EAST CENTRAL RAILWAY

L. No. 17/TRS/MEMU/JAJ/POH

Sub: Defect / deficiency found during joint inspection of MEMU rake no. 188186+188004+188177+11TC received after POH by KPA workshop on date 15.11.24.

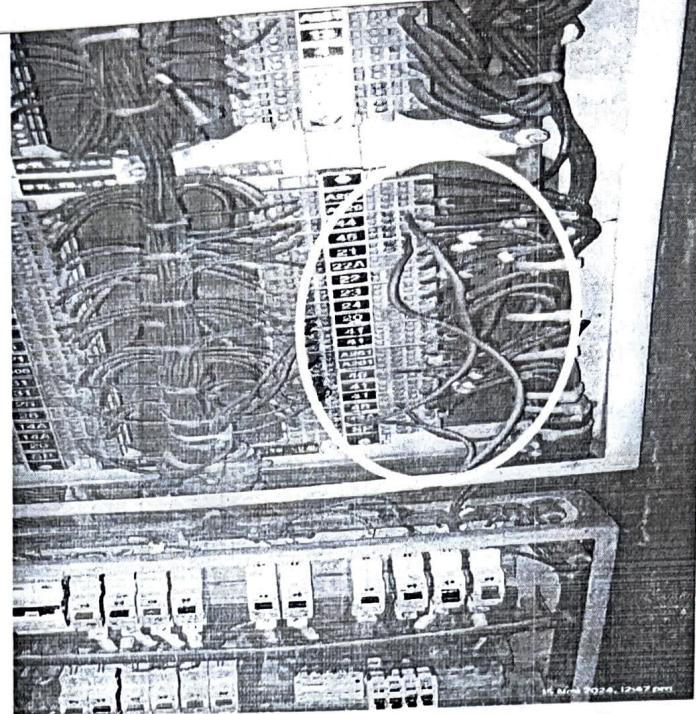
Sn.	Defects & Deficiencies found	IMAGE
1.	In MC 188177, the W1-side piston seal and Gaeco washer (make BOSCO) of WCO is defective.	
2.	In Mc no 188177 T5 aux. finger tips nut bolt are rusted.

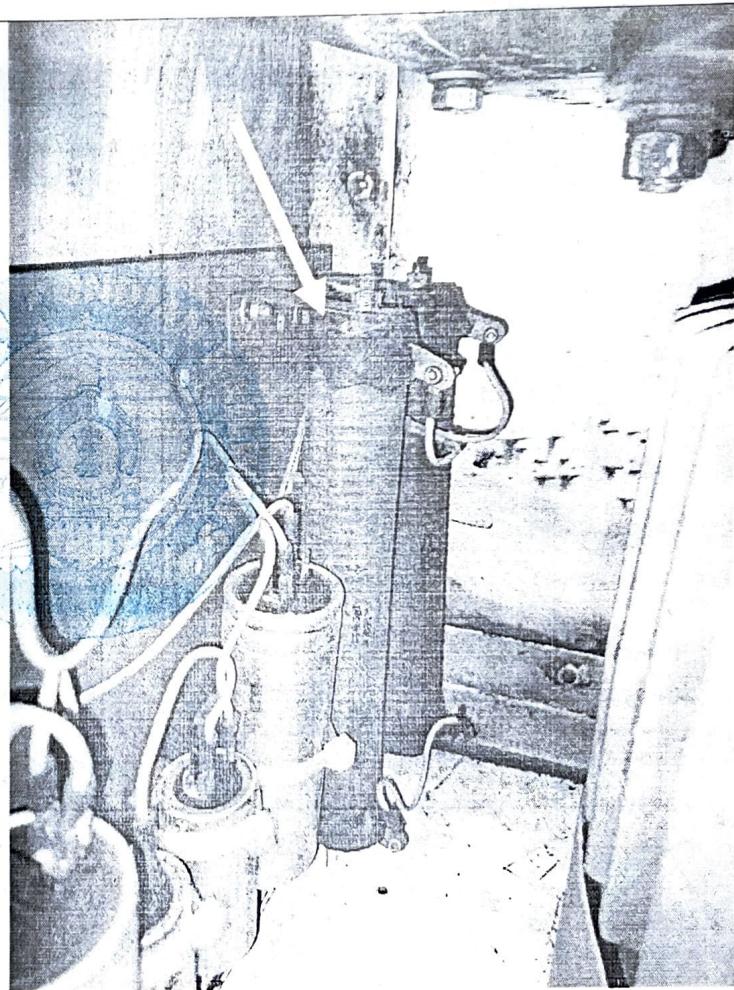
3. 44 & 45 (Fan neutral) cable found shorted with extra wire in TC no.

188256

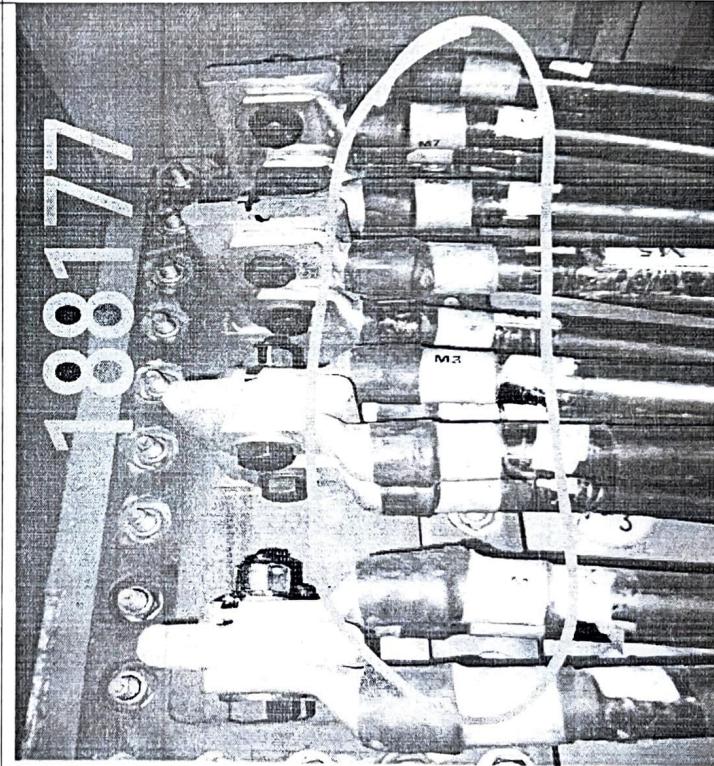
4. In MC 188177, M seal at resistance of damping CKT inside Rectifier box.

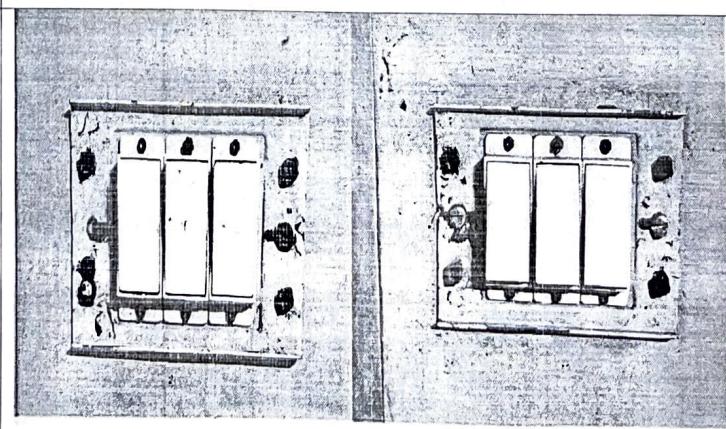
5. In MC no. 188186, 1st finger tips of M-1 is not operated freely.

6. In all MCs opaque type HSS are provided on TFP power cables inside JBs instead of transparent type.

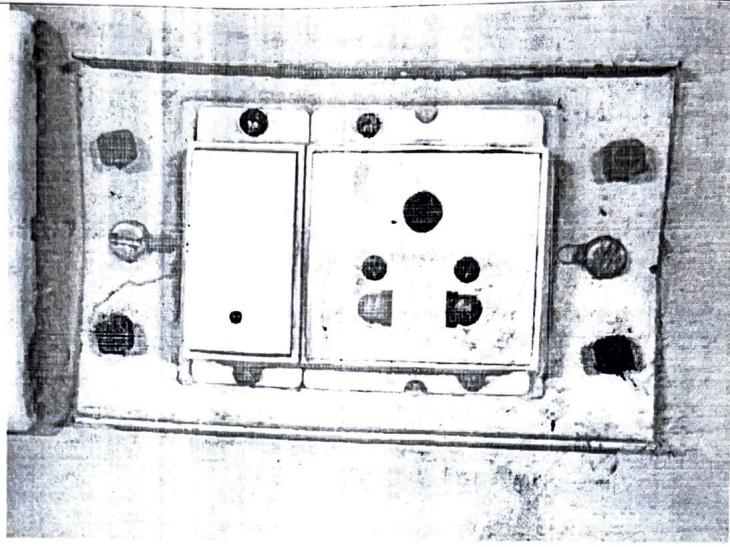
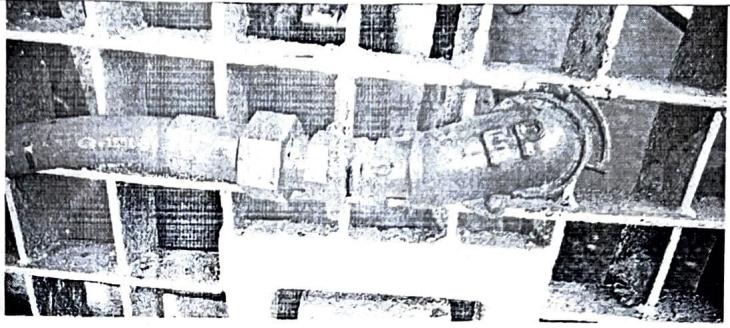
7. In TC 188540, 188261, 188256 & most of coach's Modular cover over fan switch board are not provided.

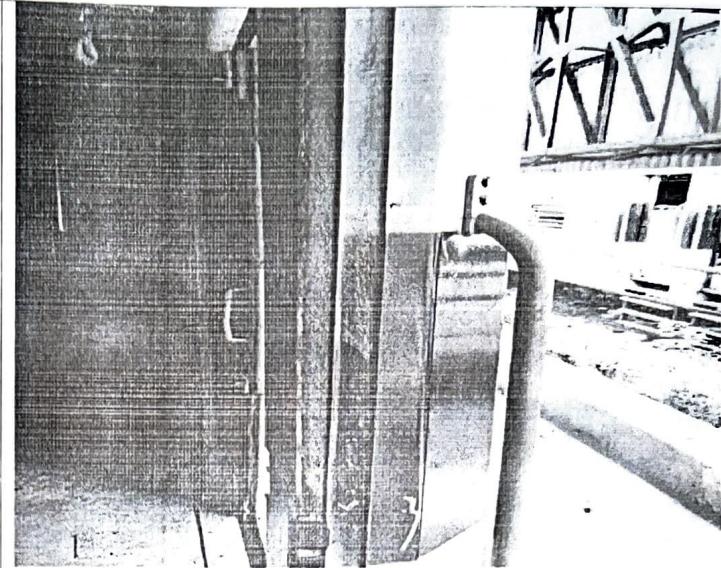
8. In MC 188004, 02 nos. of charging socket are not working & Modular cover not provided .	
9. In MC 188186 & MC 188177, MR & BP loco hose pipe are fitted with welded palm in place of original palm.	
10. In MC 188177, in MCP breather found chocked with wooden piece and its oil regulating valve cap found deficient.

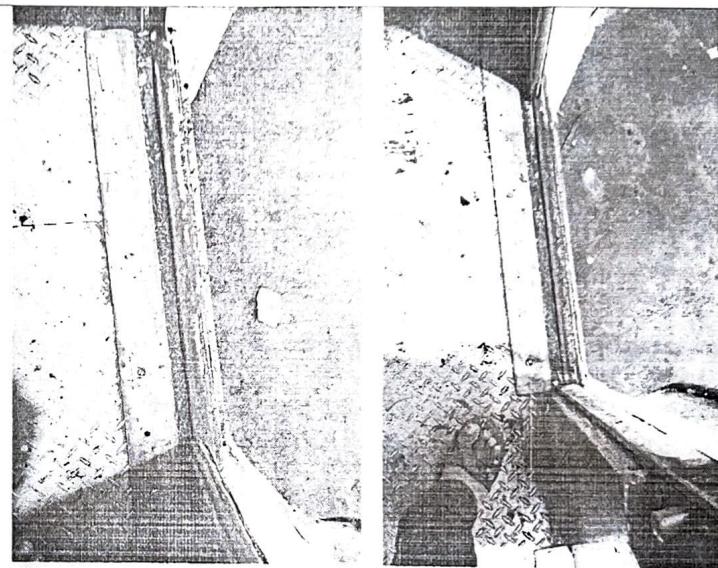
11. Sliding door gaskets found deficient in all TCs.

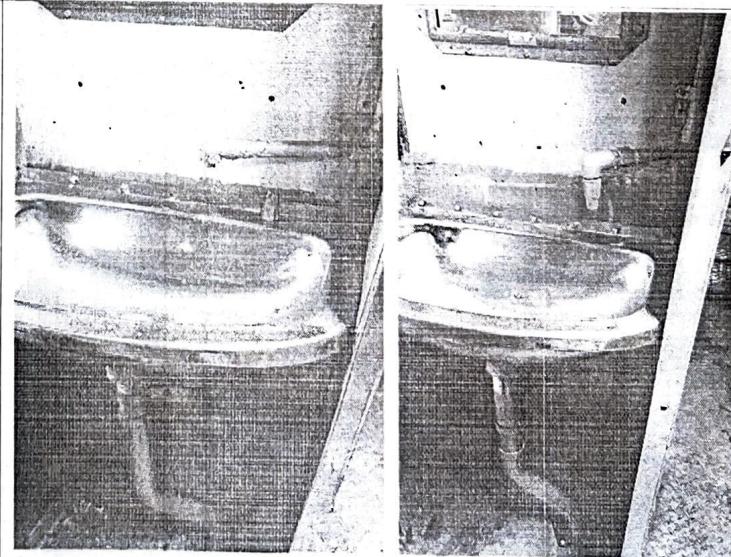
12. Bottom rail guard of sliding doors worn out in TC 188539.

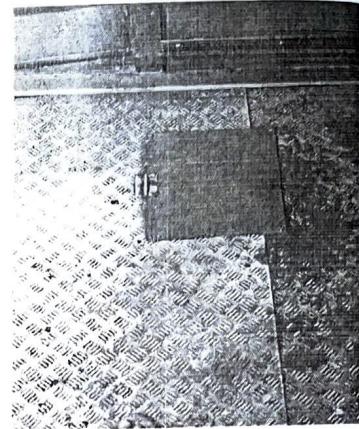
13. Gravity cock defective in TC 188540 and leakage observed in from gravity cock in TC 188256.

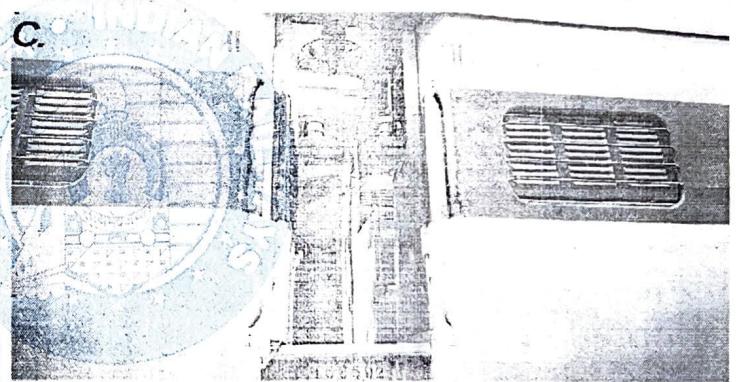
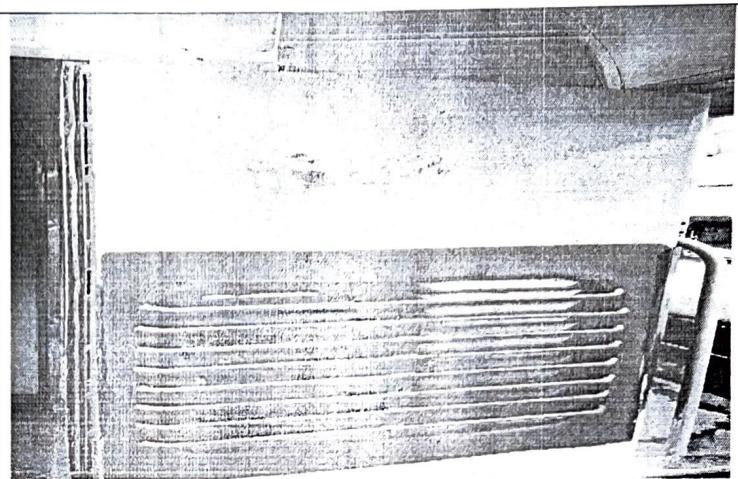
14. Buff gear plates are rusty in TC 168592 and TC 188256.

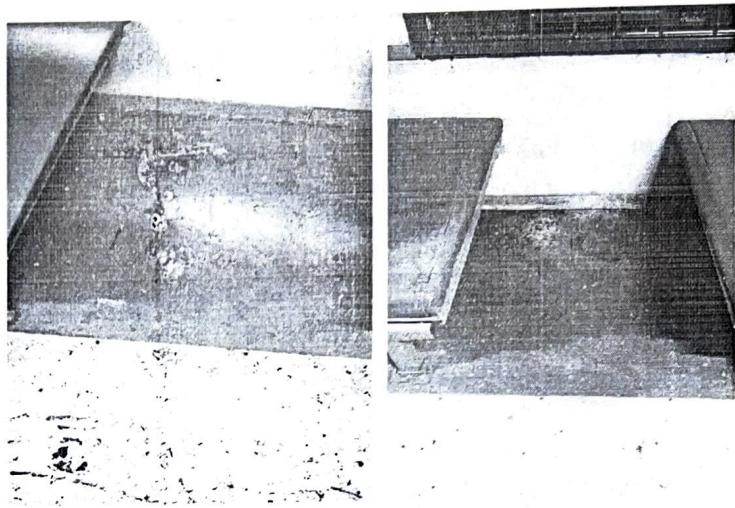
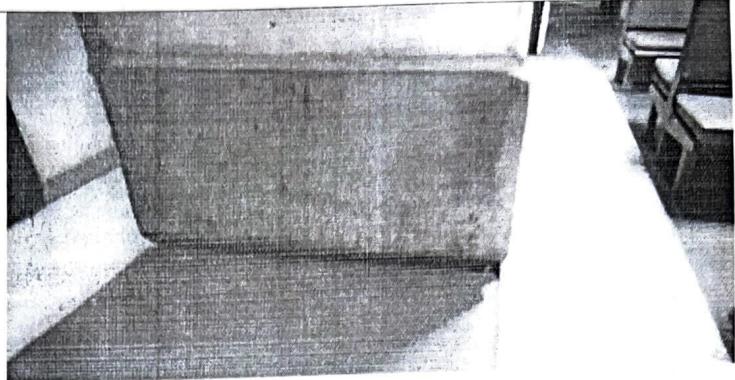
15. Coach outer body painting and hinged door painting improperly done in TC 188539, 168592, 188540, 188256, 188541, and 188177.

16. Cattle guard painting not done in MC 188004.

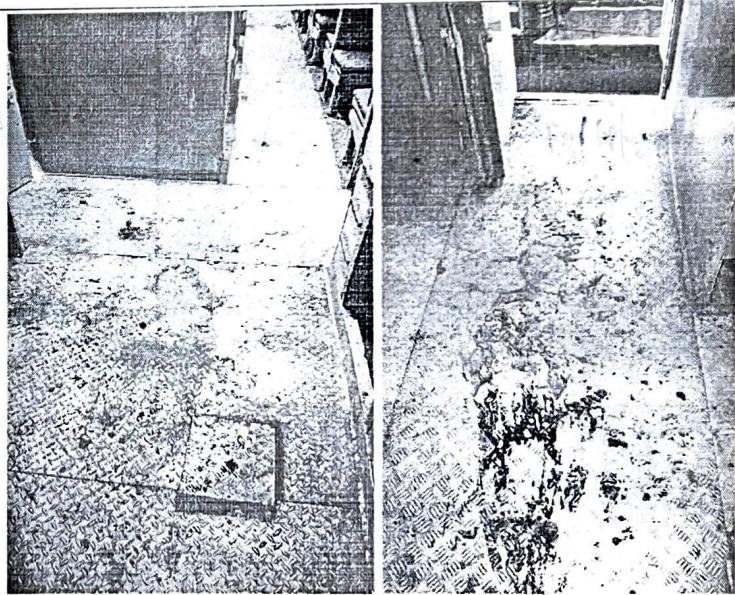
17. Passenger seats and floor mats are dirty in TC 188261; floor mat also dirty in MC 188004.

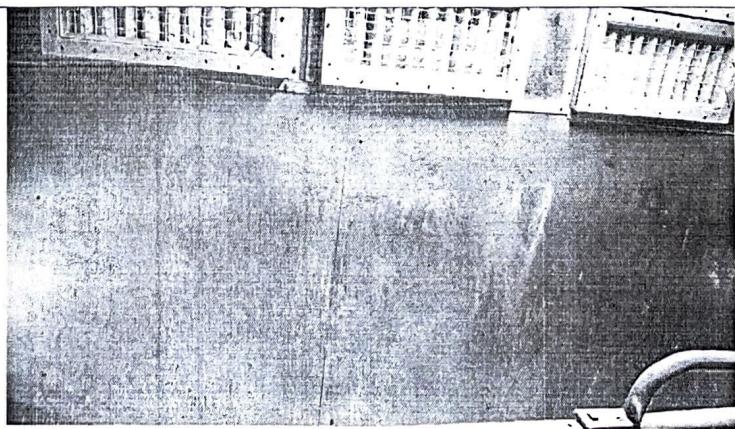
18. Coach floors, luggage racks, and steel plates inside all coaches found dirty throughout the entire rake.
